## **REMARKS**

Docket No. 1849012US1AP

Fig 5a

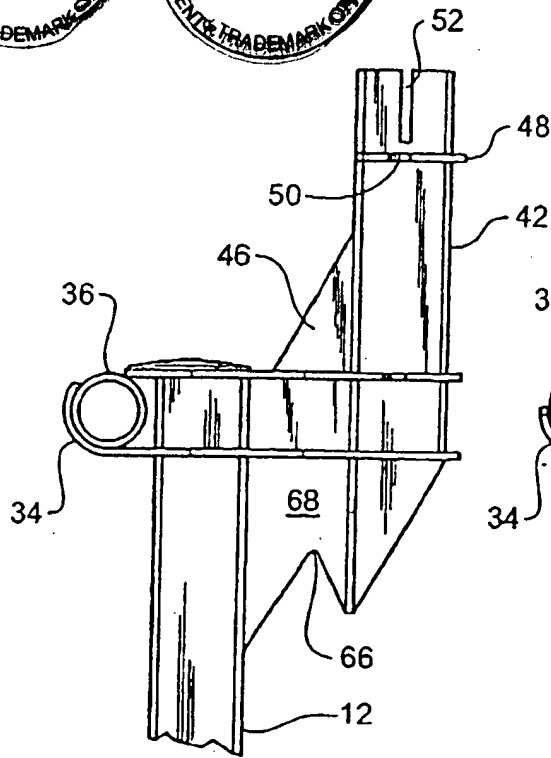
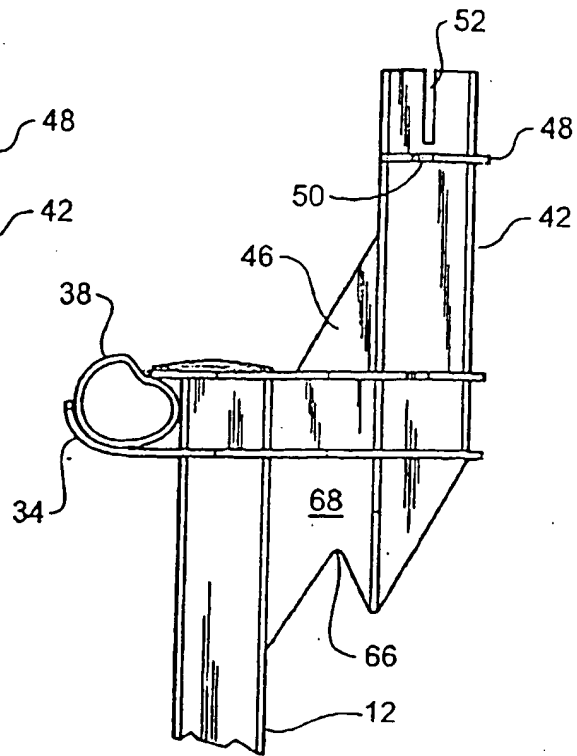
With reference to claims 16 & 17, the base includes a platform 32 or "Y" that is formed at the first end "A" directly over the first spike 12. The convex shape of the platform is seen in Figs. 4, 5a and 5b.

Fig 7b

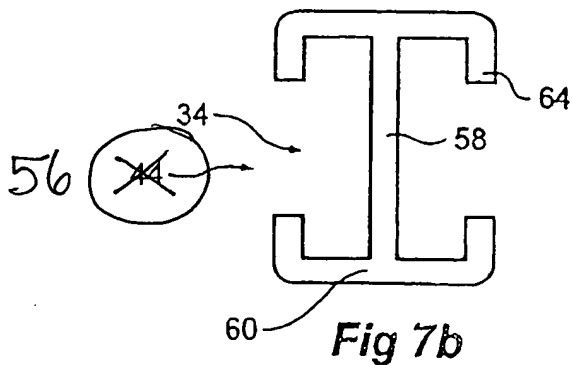
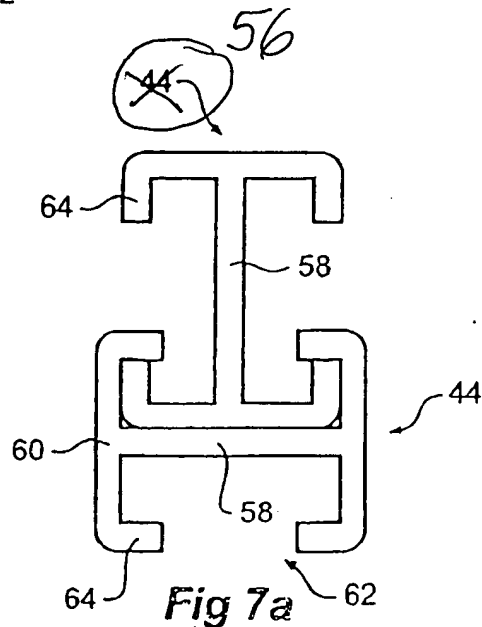
**The Examiner objected to the drawings under 37 C.F.R. 1.83(a) because they fail to show elements 56 as described in the specification.** In response, Applicant is providing a replacement sheet 5 in which the element "56" has been identified in Figs. 7a and 7b. Applicant is also providing a marked-up copy of sheet 5 to indicate the numbering change.

Marked up  
Fig 2

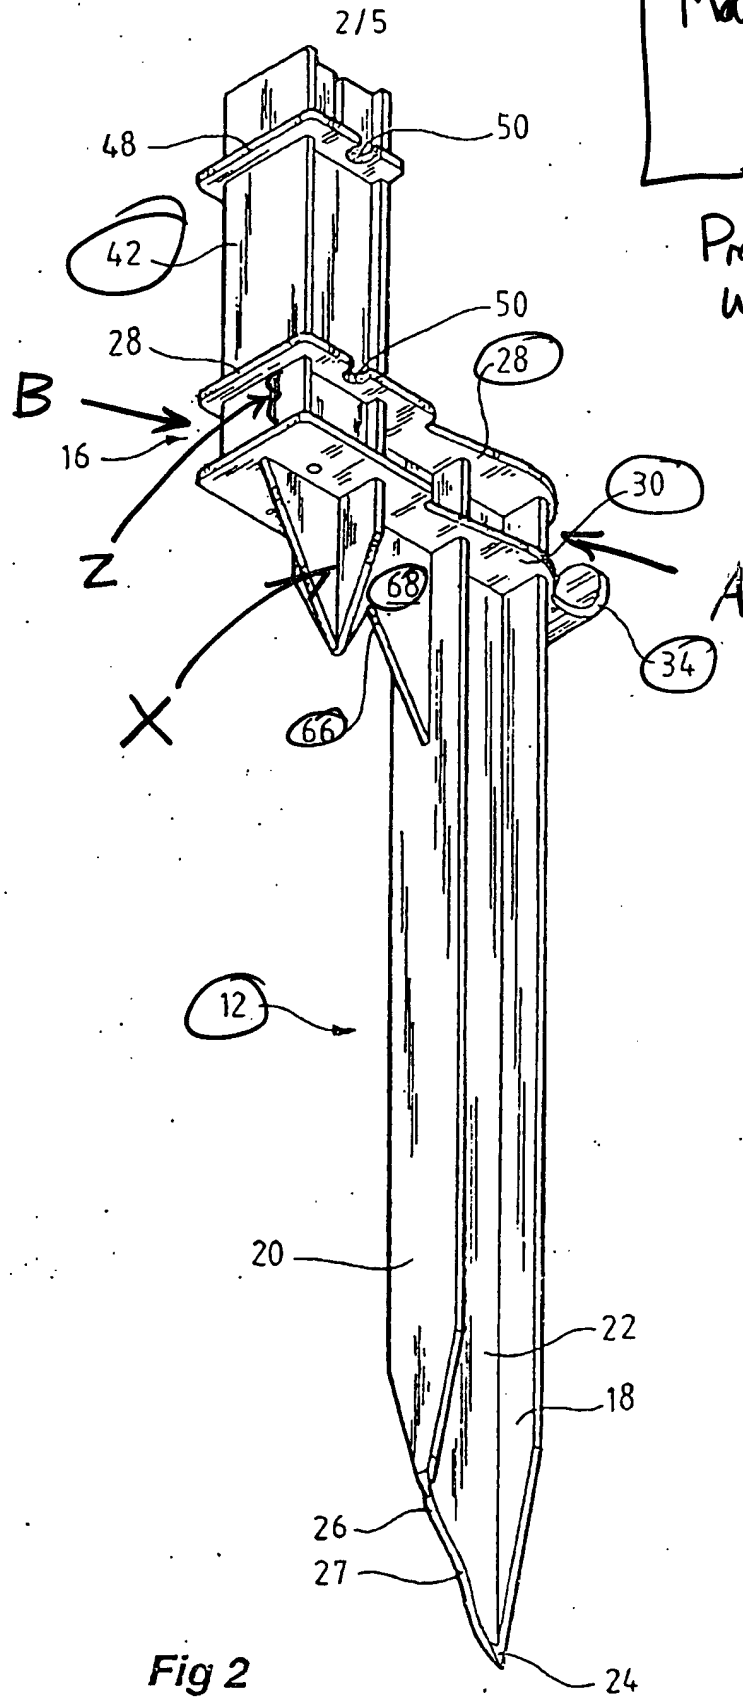
**Applicant has added new claims 15-20 to more clearly define the offset relationship between the main anchor of the device and the receptacle that holds the end of the elongated spike.** Applicant attaches marked-up Figures 1 and 2 to provide support for these new claims. With reference to claim 15, the stake support includes a base defined by members 28 and 30 (Fig. 2). The base has spaced-apart first and second ends - marked "A" and "B" respectively. A first spike 12 extends downwardly from the lower surface 30 at the first end "A" of the base. A second spike, labeled "X", extends downwardly from the lower surface 30 at the second end "B" of the base. A stake-retaining receptacle 42 extends upwardly from the upper surface 28 of the second end ("B") of the base.

With reference to claims 18 and 19, the upper and lower surfaces 28, 30 of the base are separated from each other by an intermediate section (marked Z). The curved extension 34 (Fig. 1) is integral with lower surface 30 and curves upwardly toward the upper surface 28. The relative height and thickness of the curved extension are best seen in Fig. 4.
